### Devils Bridge

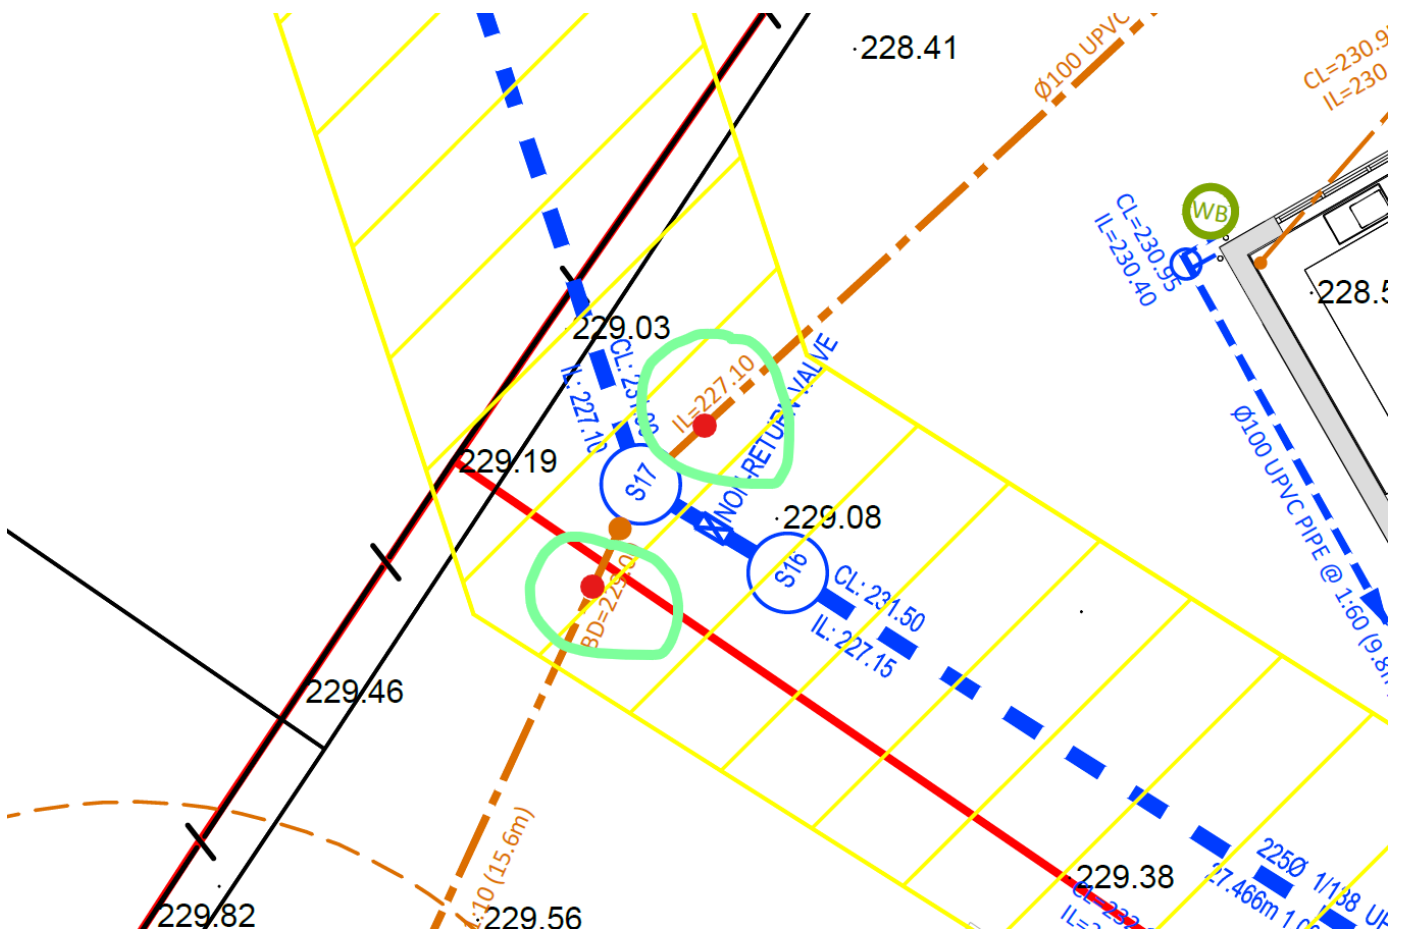
In terms of a sample chamber I am presuming this is a plastic chamber with a sump in the bottom so samples can be take for analysis, I have highlighted two location in the green circles on the below plan as to where I would expect them to be.

For the chambers themselves I would propose a plastic catchpit chamber as shown below.

If you could confirm that this will be suitable then we can update accordingly.
